RotorSport UK Ltd

Service Bulletin

SB No.: 024 issue 2	CCAR No.: None	Classification:
Aircraft type & model (applicability) RotorSport UK MT-03 and MTOsport	Aircraft serial Nos. effected RSUK/MT-03/all RSUK/MTOsport/all	OPTIONAL or RECOMMENDED or MANDATORY

Problem description & cause of problem if known
 The standard halogen lamp (RSD4163) fitted to the landing lights of MT-series aircraft has a relatively high power consumption (12V 50W each) and if used continuously can become hot. An optional LED lamp is now available (RSD4617) that consumes considerably less power (12V 4W each) and runs cooler.

RSD4617 LED (left) and RSD4163 halogen (right)

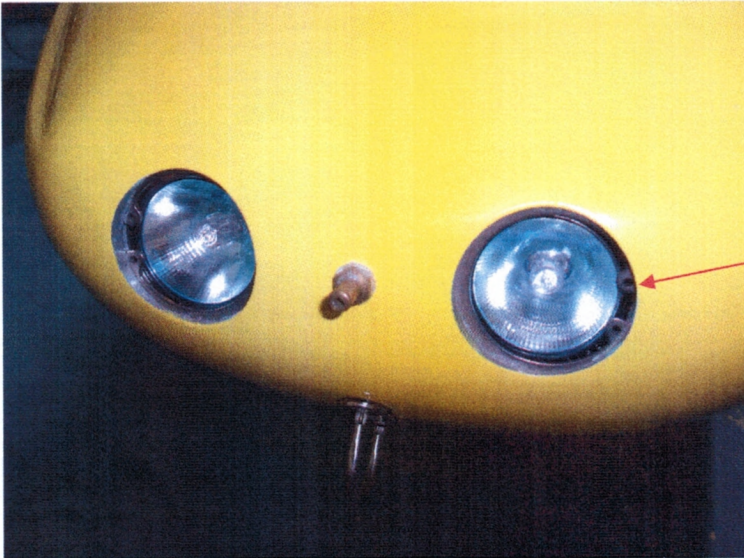
Parts required to implement this bulletin
 2-off LED lamp RSD4617. (Note that this supercedes RSD4511 previously approved for fitment under MC-139)

Earlier method of lamp retention

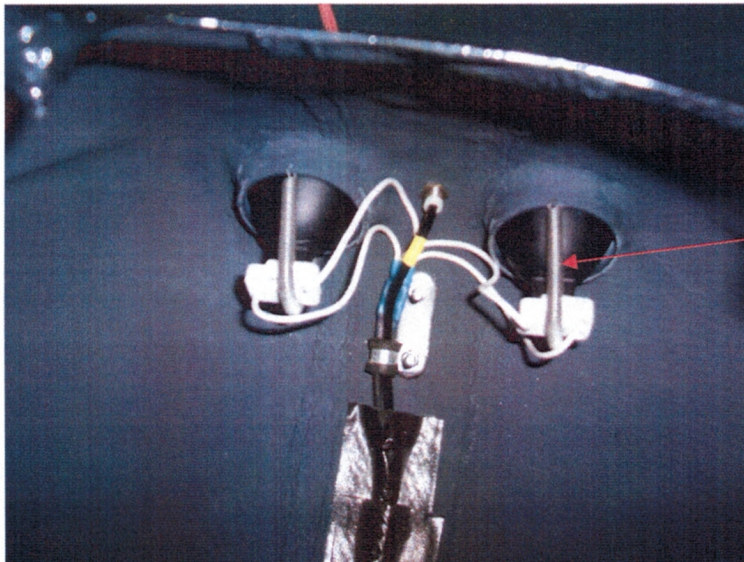
1. If a luggage locker is fitted then remove the hatch cover. If a landing light shield is in place then remove (SB-023 refers).
2. On aircraft manufactured prior to 2010 each lamp is retained by a circlip accessible outside the nose – remove the circlip then the lamp. On later aircraft each lamp is retained by a tension spring accessible through the hatch – pull one end of the spring until its hook can be removed from the surround then remove the lamp. NB: On very early MT-03 aircraft the lamps are bonded into the nose moulding by a bead of Sikaflex EBT mastic. This must be cut-away using a sharp knife, the lamp replaced and the Sikaflex reinstated. Access is gained by reaching under the instrument panel and fwd of the rudder pedals
